Mitigation Plan
Horne Creek Tributaries Mitigation Project
Surry County, North Carolina
FINAL VERSION

NCDEQ DMS Project Identification # 100026
NCDEQ DMS Contract # 7181
Yadkin River Basin (Cataloging Unit 03040101)
USACE Action ID Number: SAW-2017-01510
Contracted Under RFP # 16-006993

Re: NCIRT Review and USACE Approval of the Horne Creek Tributaries Mitigation Plan; SAW-2017-01510; NCDMS Project # 100026

SUBJECT: Horne Creek Tributaries Mitigation Site - NCIRT Comments during 30-day Mitigation Plan Review

FIGURE
9

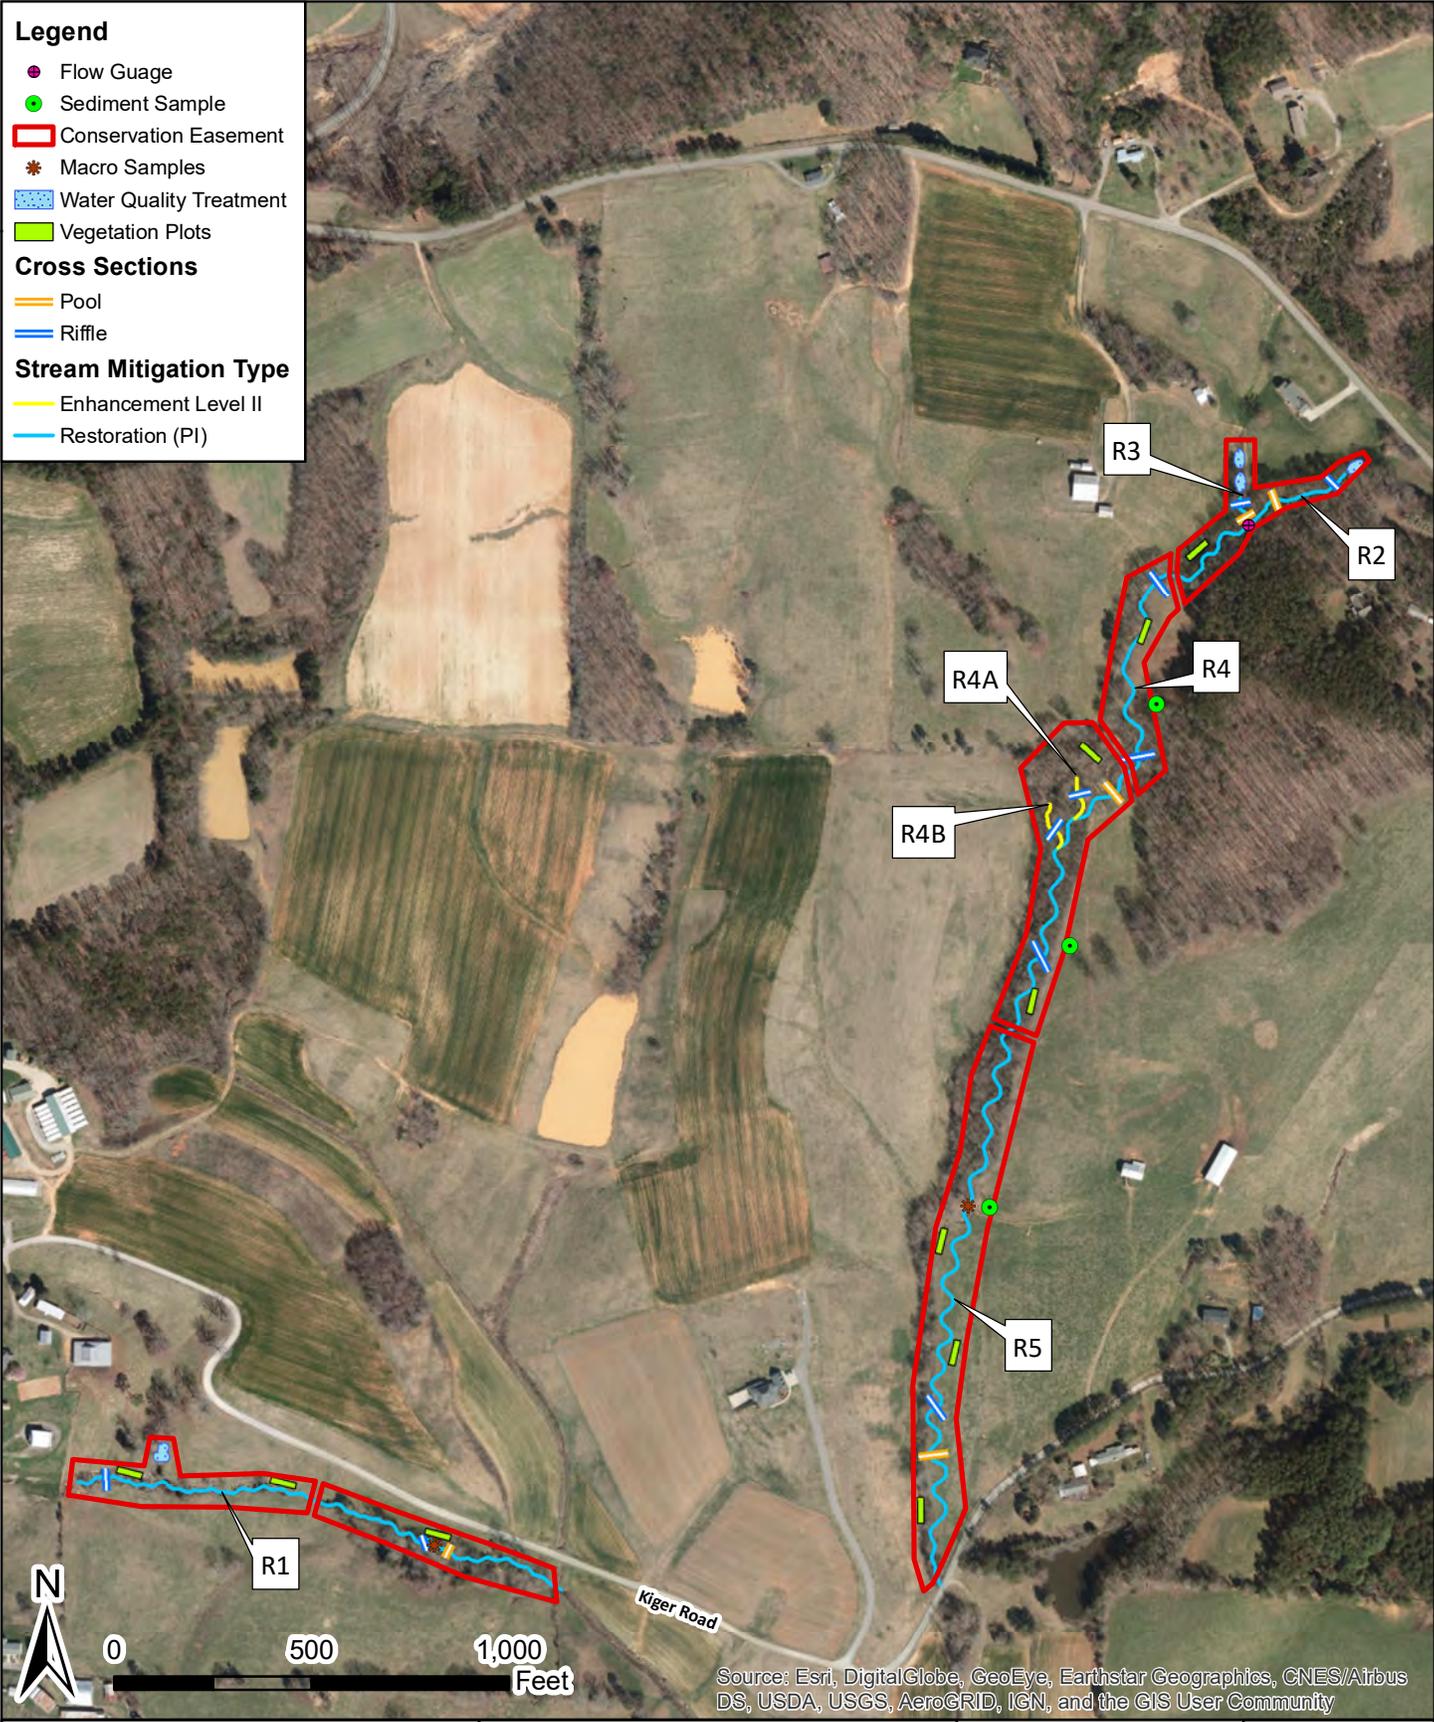
4. It would be helpful to depict photo points on Figure 9. Response: We have added existing conditions photo points on Figure 6 to correspond with the site photographs located in Appendix 2. Post-restoration photo point will be included with the MY0 Baseline Report - Current Conditions Plan View (CCPV) map to document and quantify the visual assessment throughout the monitoring period.

FIGURE
11a

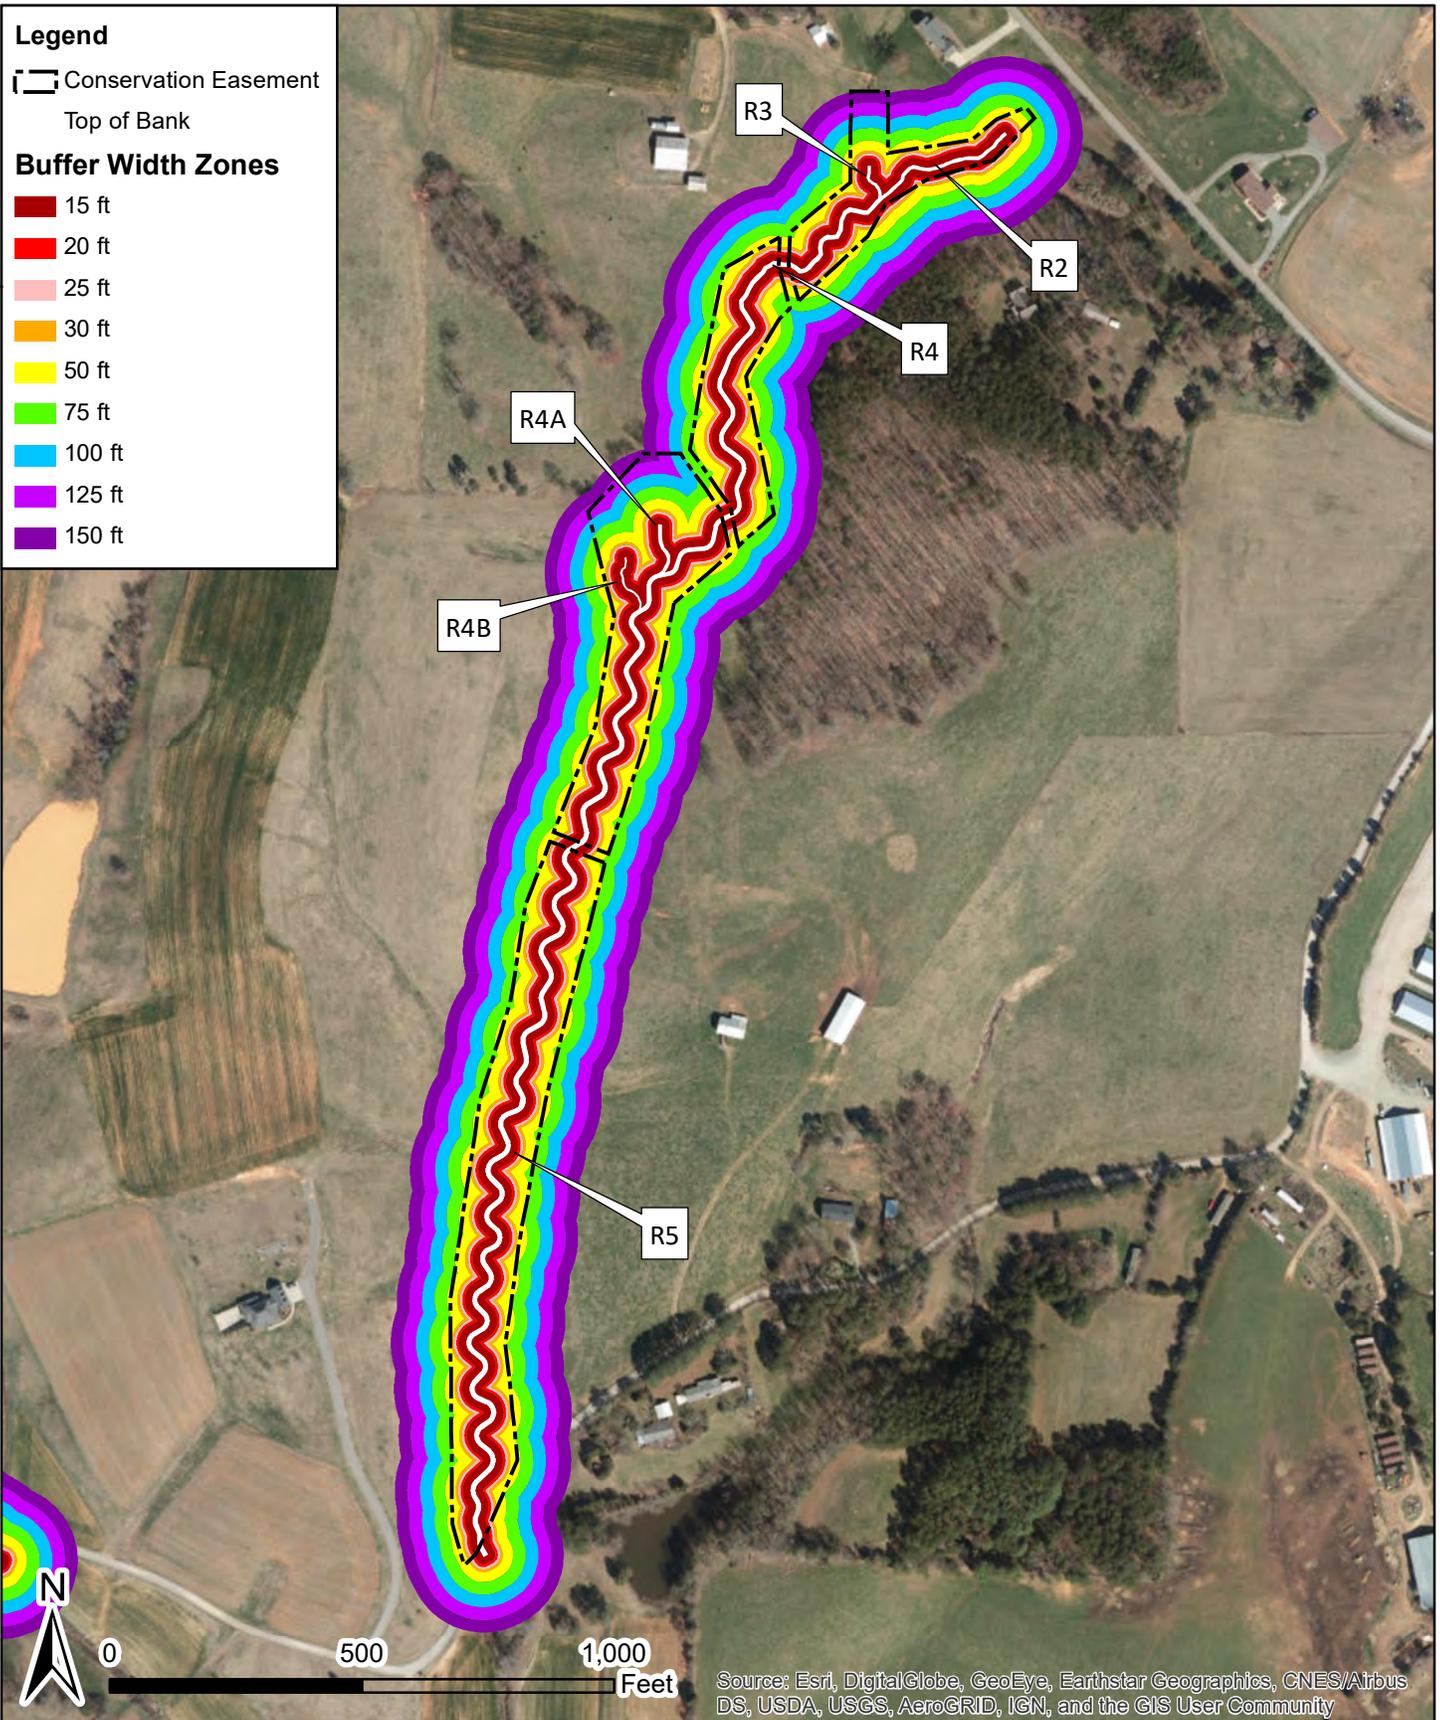
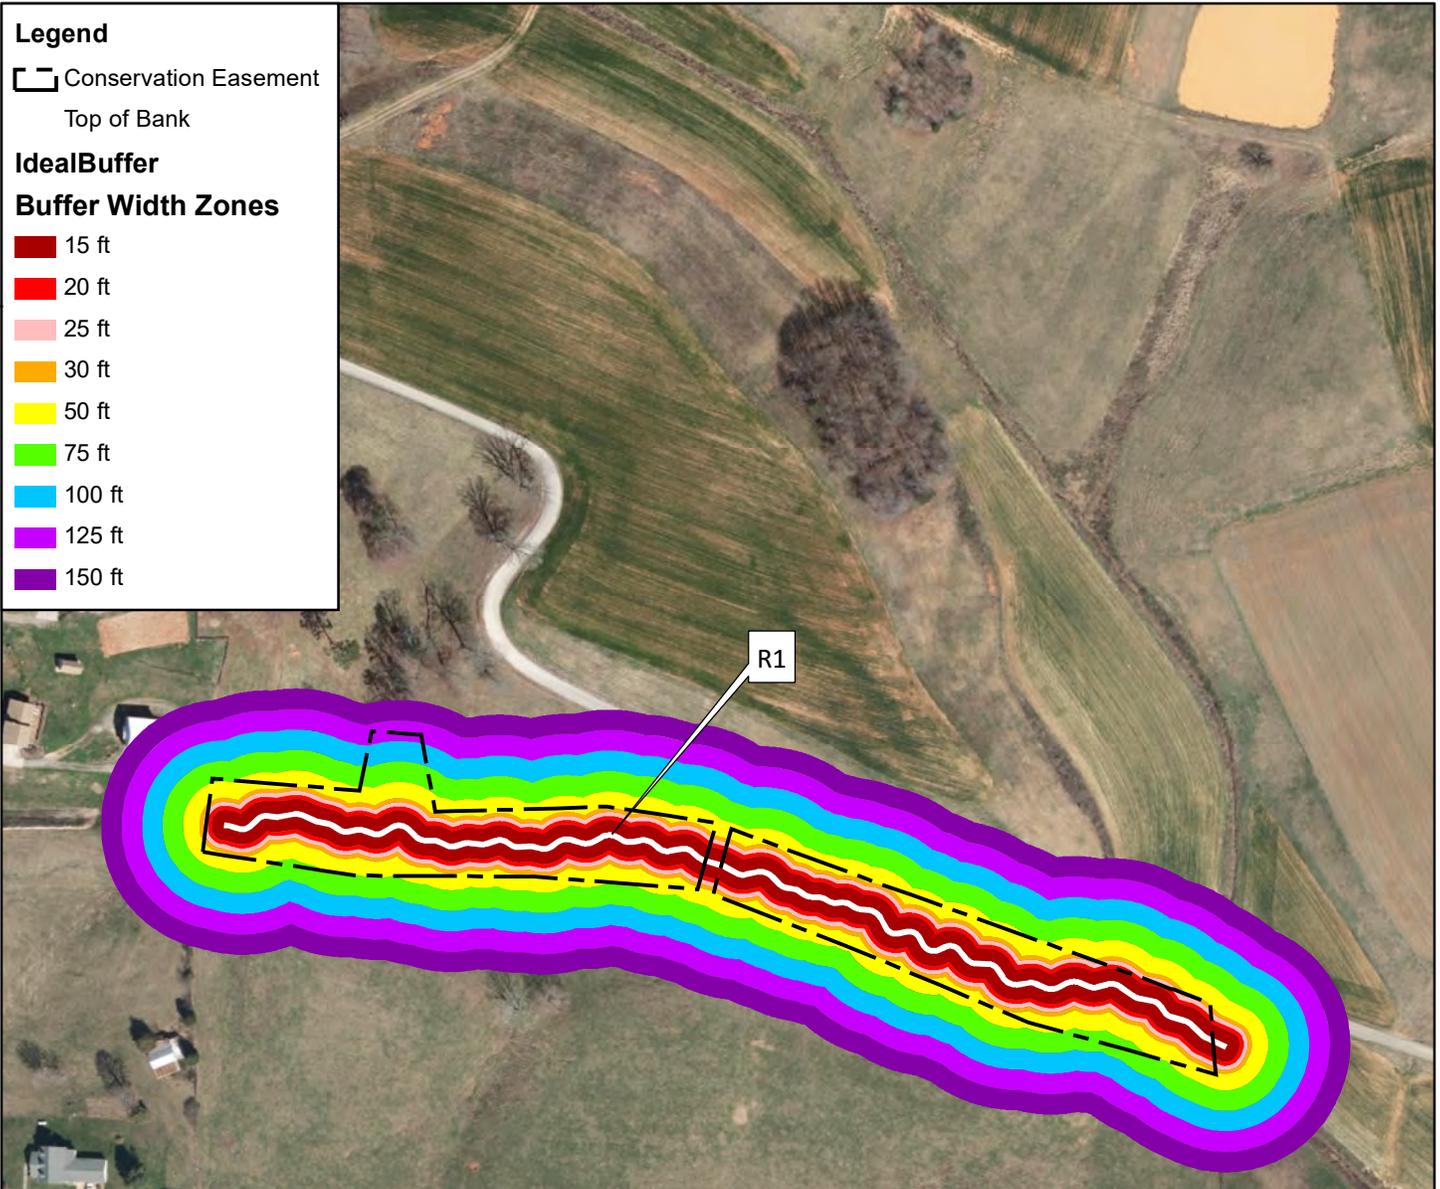
11. Buffer Widths: Portions of R1, R2, and R5 do not meet the minimum buffer width of 30 ft. This is approximately 11% of the total restored length, which exceeds the guidance allowing no more than 5% of the total project length. Would the 11% change if you calculated the total project length, verses only using the restored length? If the result is still over 5%, the buffer tool needs to be used. If the Buffer Tool is used, please clearly show the loss or addition of credits in the Table 1 and 14. a. The Buffer calculation table in the appendix, Table 1 and Table 14 all appear to have different credit totals. Please clarify. Response: As described in the DMS Final Draft response comments, WLS has made every effort to acquire the necessary easement areas to meet or exceed the minimum buffer width requirements. However, some areas along Reaches R1, R2 and R5 do not meet the minimum 30' buffer requirement. This was due in part to of lack of landowner involvement or where the constraints by ROWs resulted in acute angles in the easement. The total length affected for the entire project is approximately 600 LF which is approximately 11% of the total restored project length. Per the guidance in the Wilmington District Stream and Wetland Compensatory Mitigation Update, North Carolina Interagency Review Team (USACE, 2016) under Section XI. Stream Buffers, heading A. Required Minimum Buffer Widths, subheading 5: Where streams intersect with project boundaries (e.g., property lines, farm crossings, utility easements, etc.), it was not possible for buffers to meet the minimum standard width all the way to the end of the channel where the intersection occurs at an acute angle.

WLS used the DMS buffer calculation tool and USACE-Wilmington District Stream Buffer Credit Calculator to help tabulate stream credit gains/losses. WLS is proposing 5,389 stream mitigation credits for the affected project reaches. The net change after buffer adjustments is approximately +25 stream credits as shown on Figures 11a and 11b and in the Wilmington District Stream Buffer Calculator output in Appendix 2. Many buffer widths greatly exceed the 30-foot minimum which includes the water quality treatment features within the easement boundary. WLS updated Tables 1 and 14 to include the buffer tool calculations as requested and included additional notes to clarify the buffer tool and stream mitigation credit calculations and adjustments as described further in Section 6.1.

TYPICAL SECTIONS

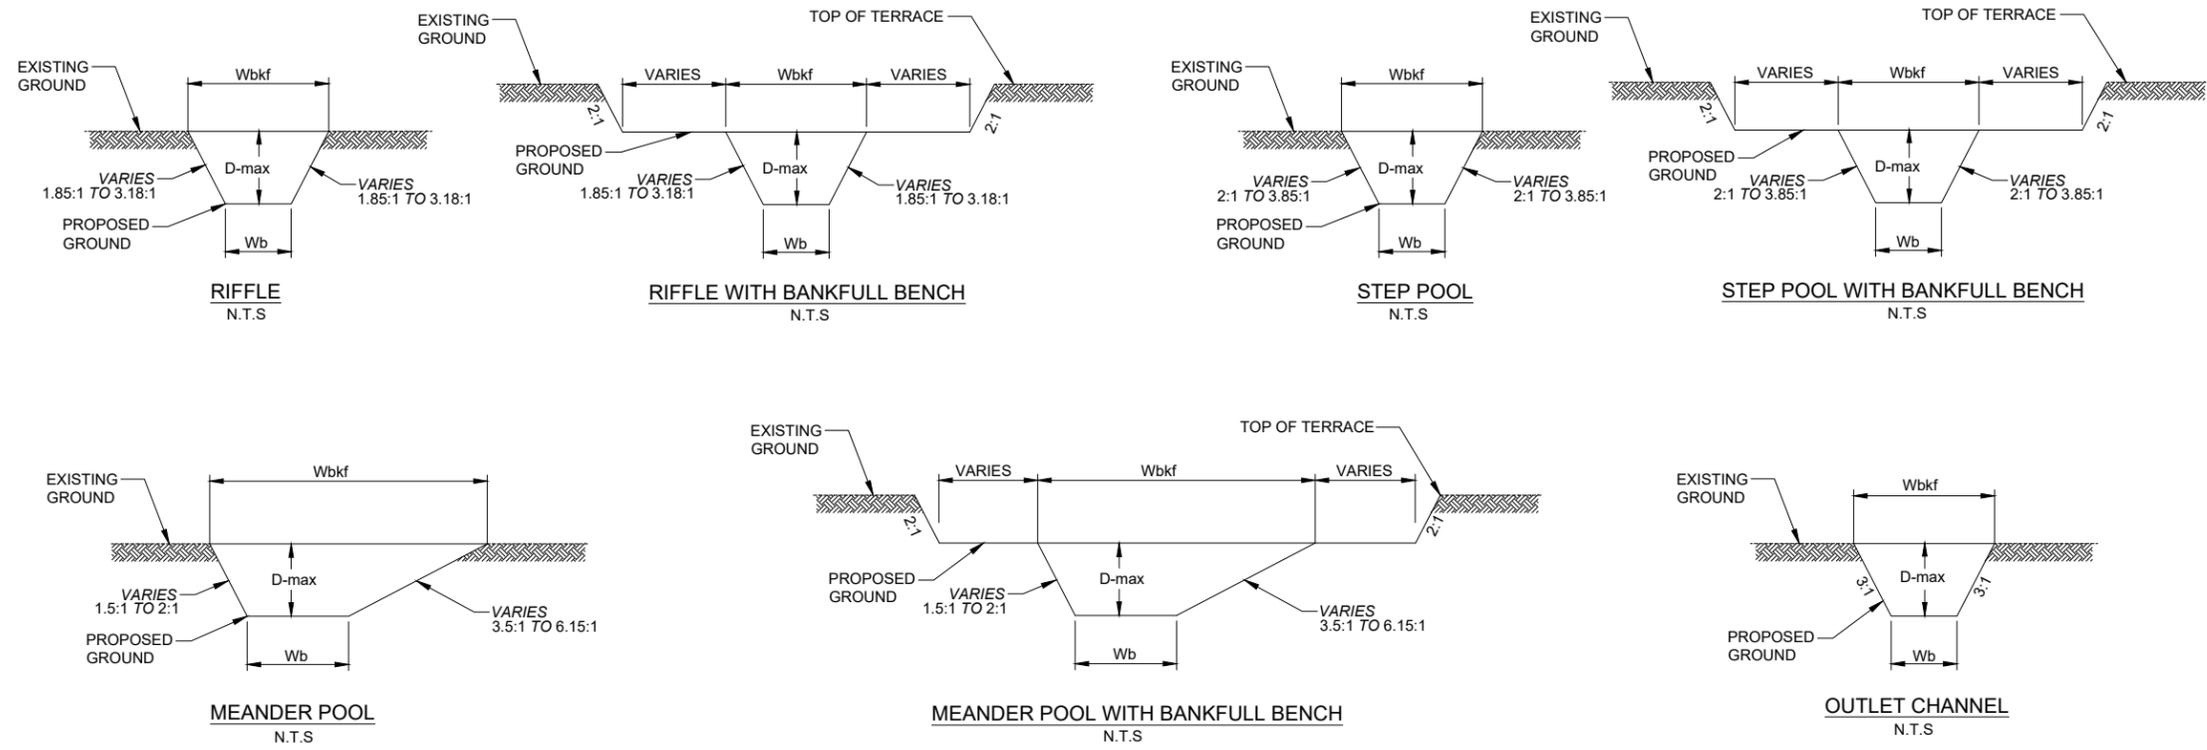
6. Design sheet 3 - DWR would prefer to see specific bank slopes identified on the typicals. We realize these slopes may vary, however; we would prefer to see the slopes specified even if they are "on average".

Response: Revised the typical sections on design plan sheet 3 to include average side slopes.
